Stateside Subdivision

SUBFY 2025-0002

Preliminary / Final Plat

July 8, 2025

Landscape

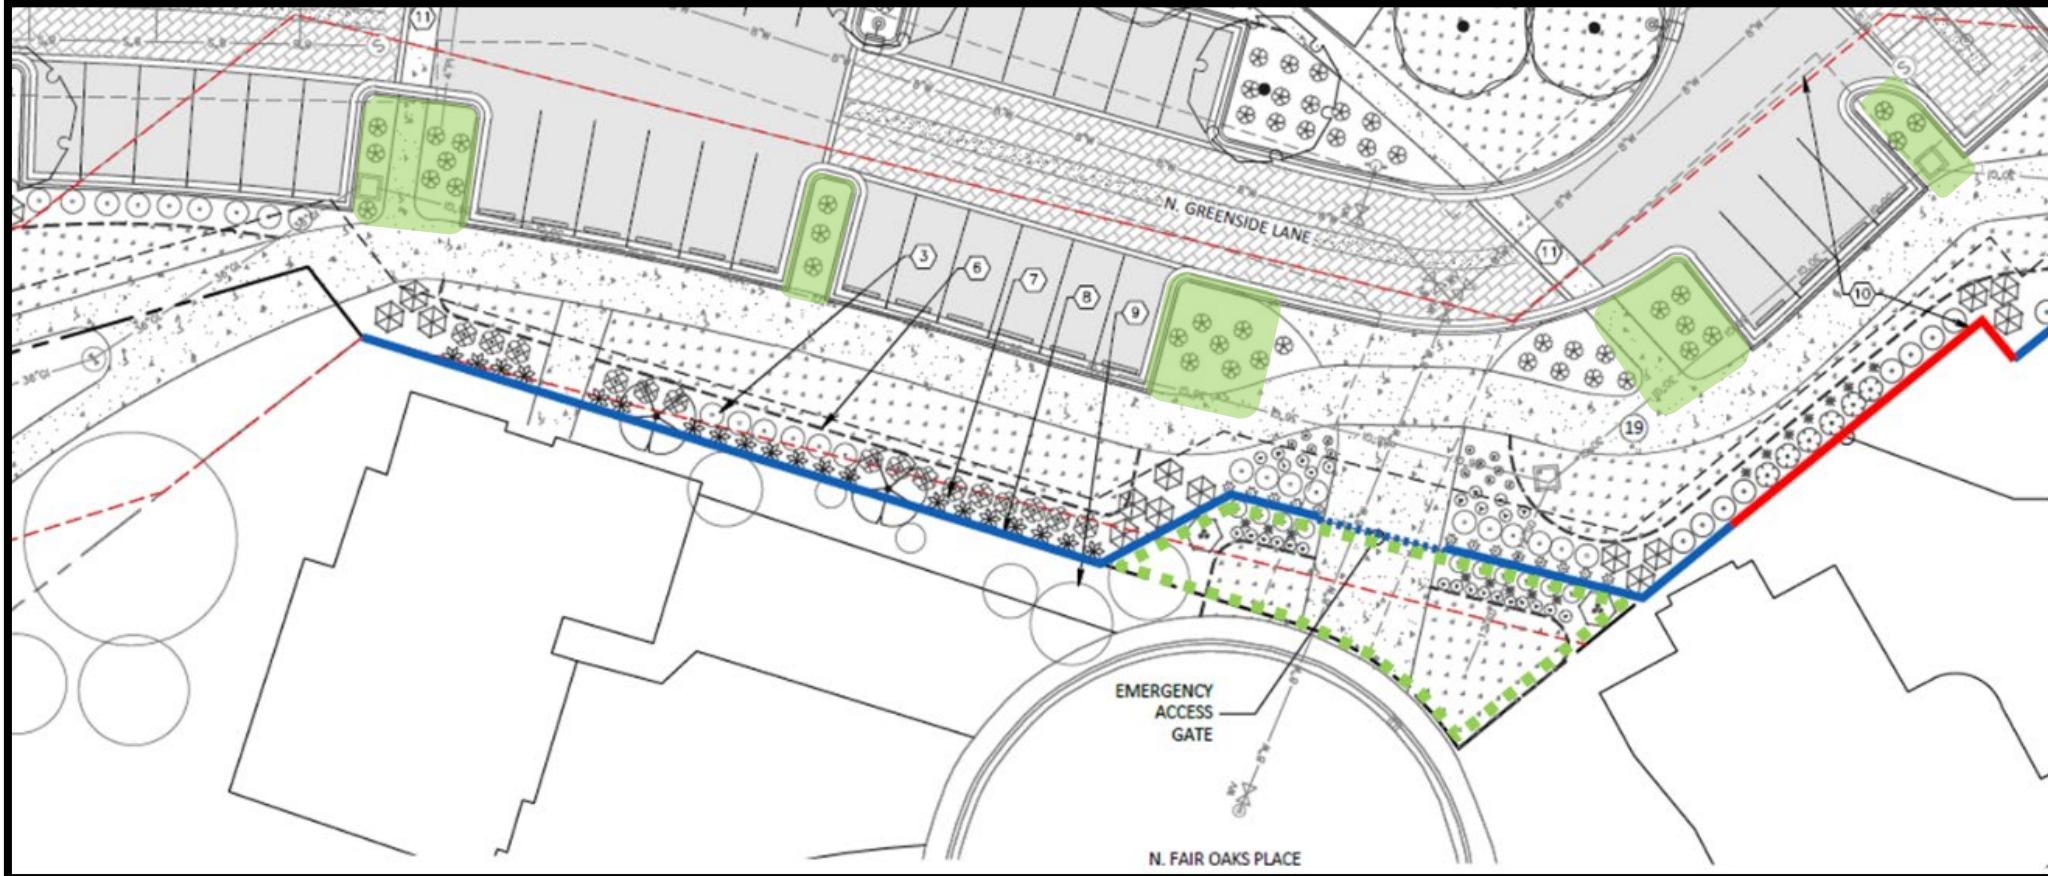
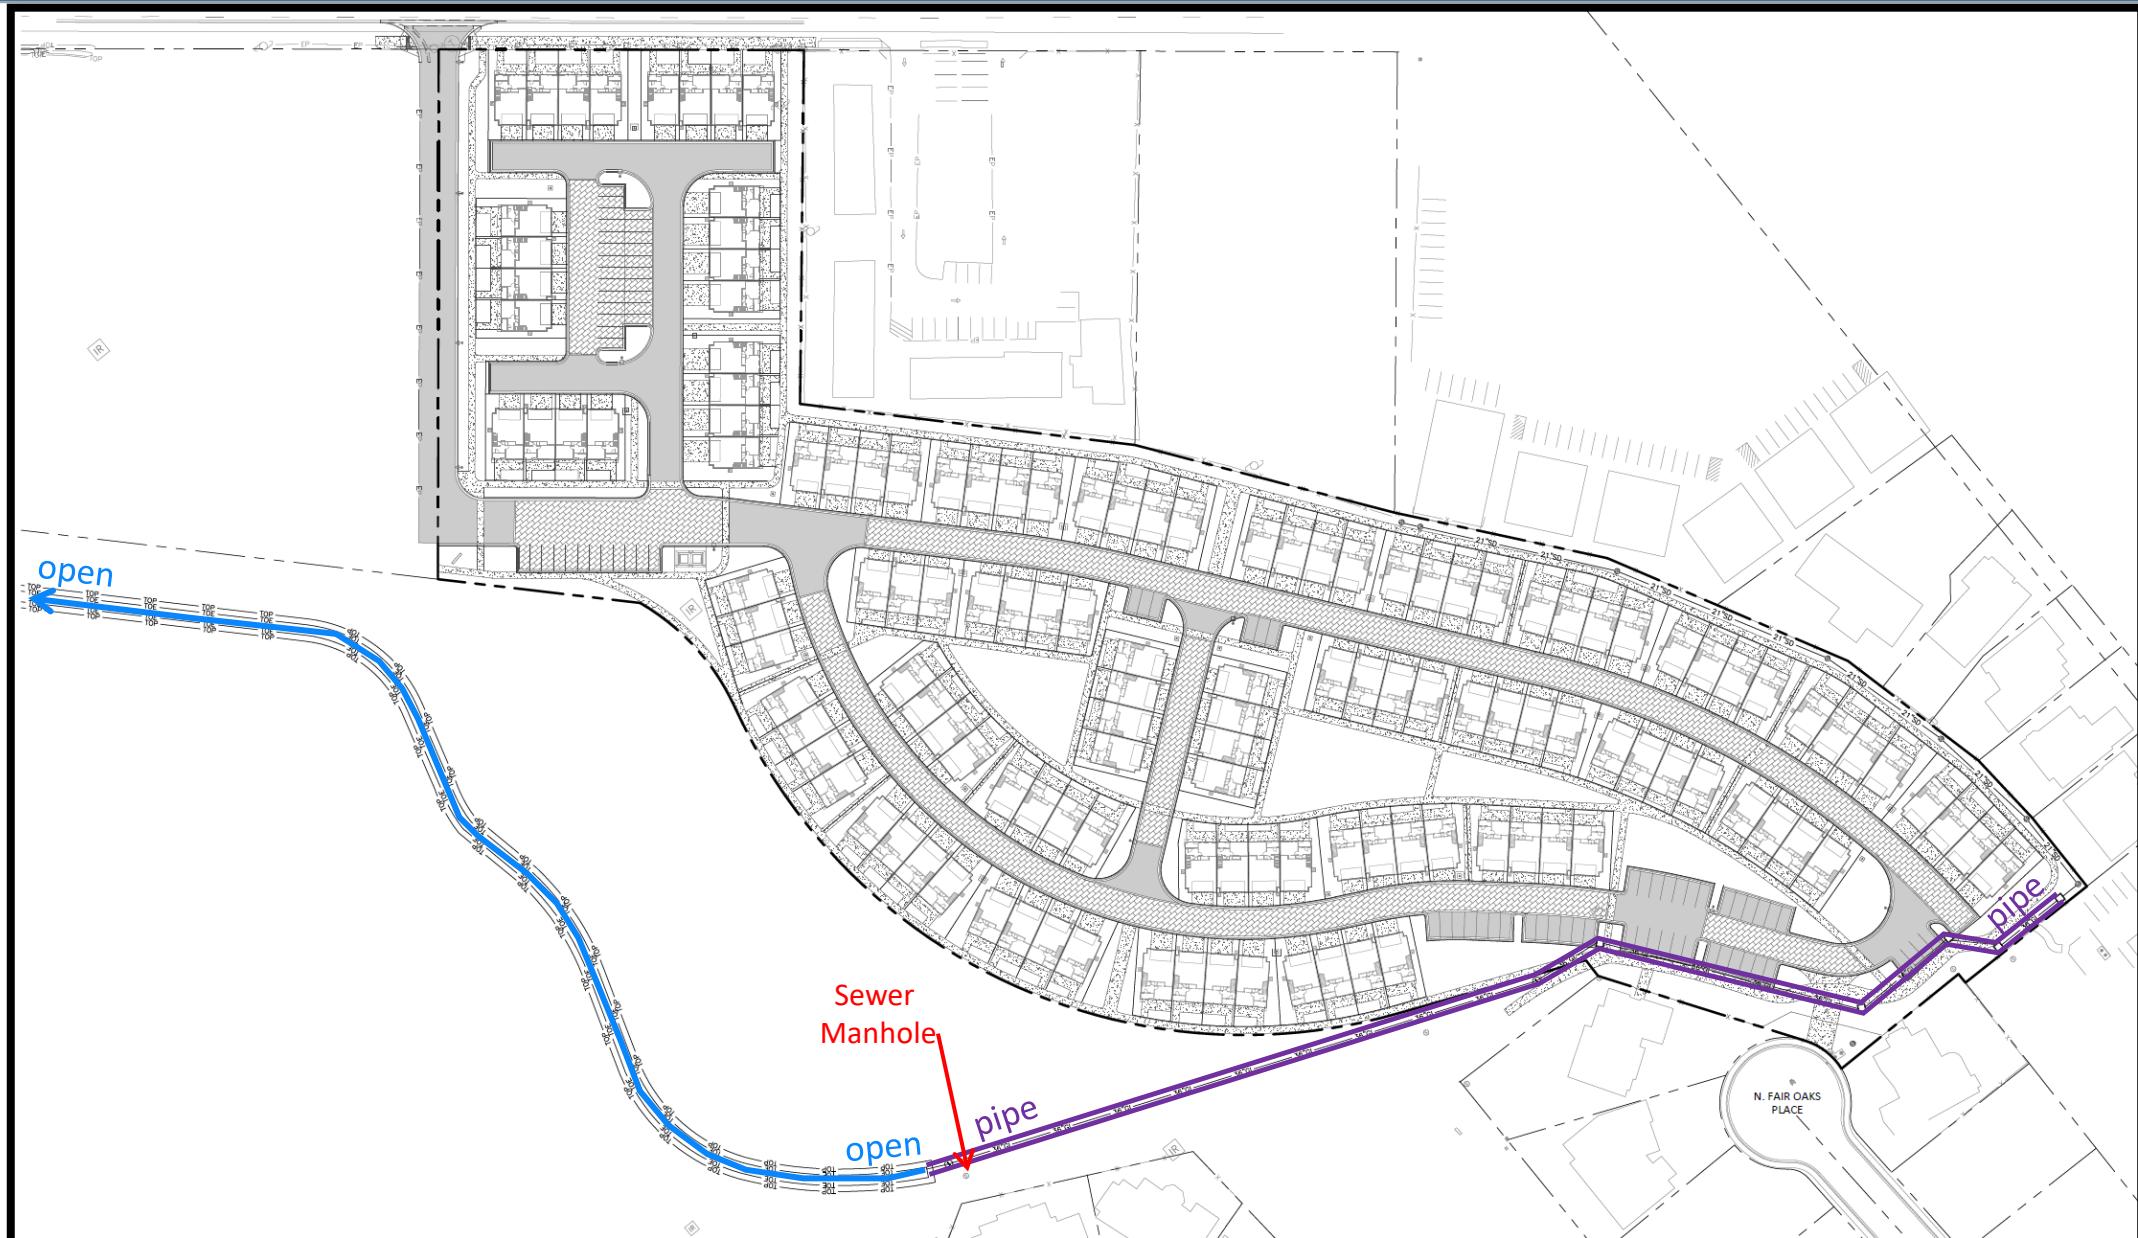
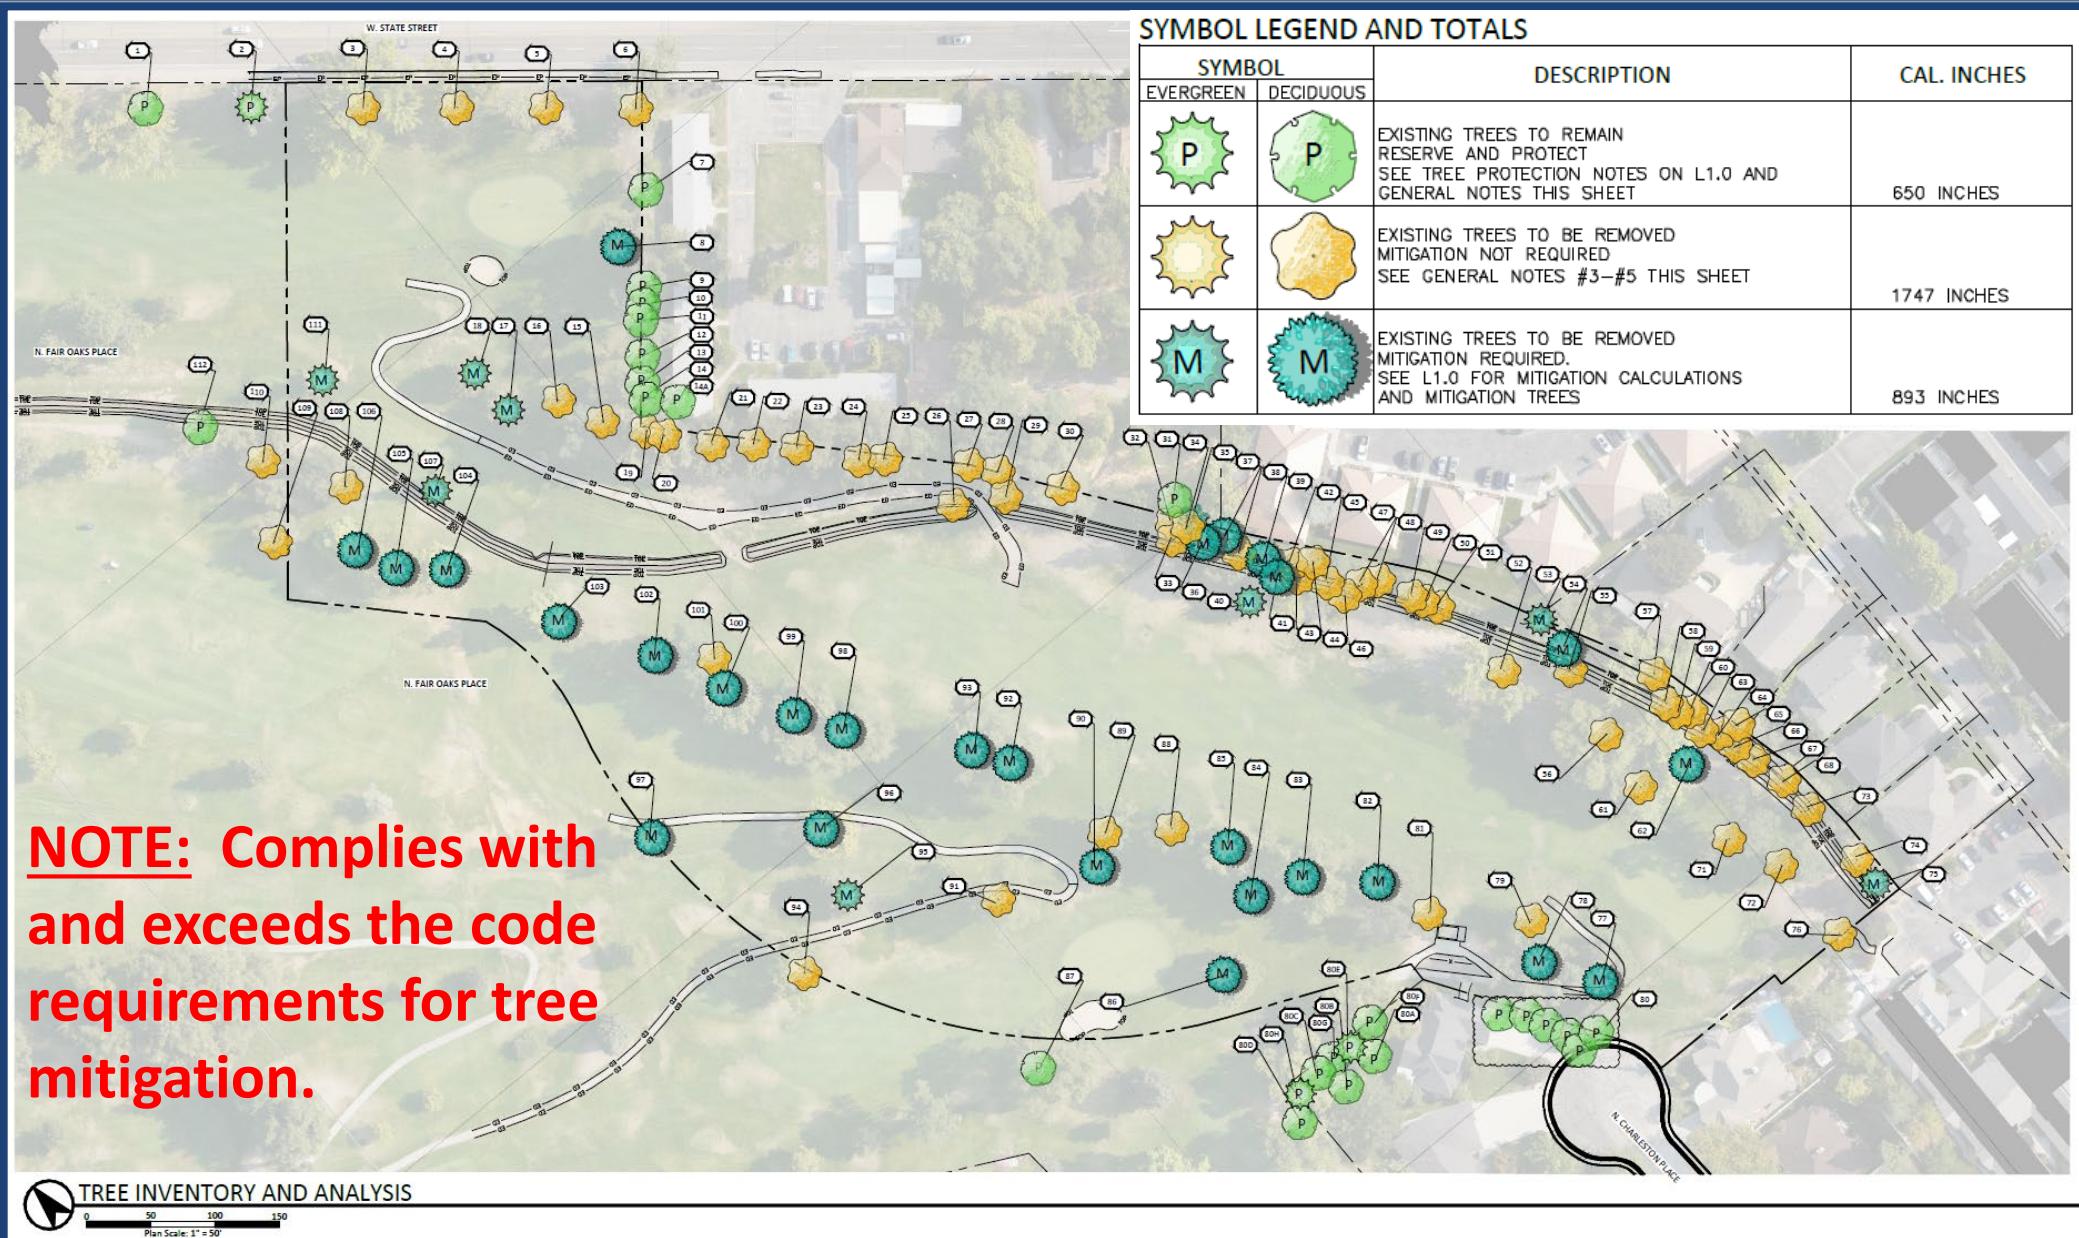
Southern boundary buffer

- 12-foot Buffer

Landscape Islands

- Irrigation Easement

- Piped & Open

- Complies with Code

Trees cannot be planted within the landscape islands because of Irrigation Easement.
However, the required trees will still be planted.

REMOVE: Requirement
for continuous 6-foot-tall
vegetative screen
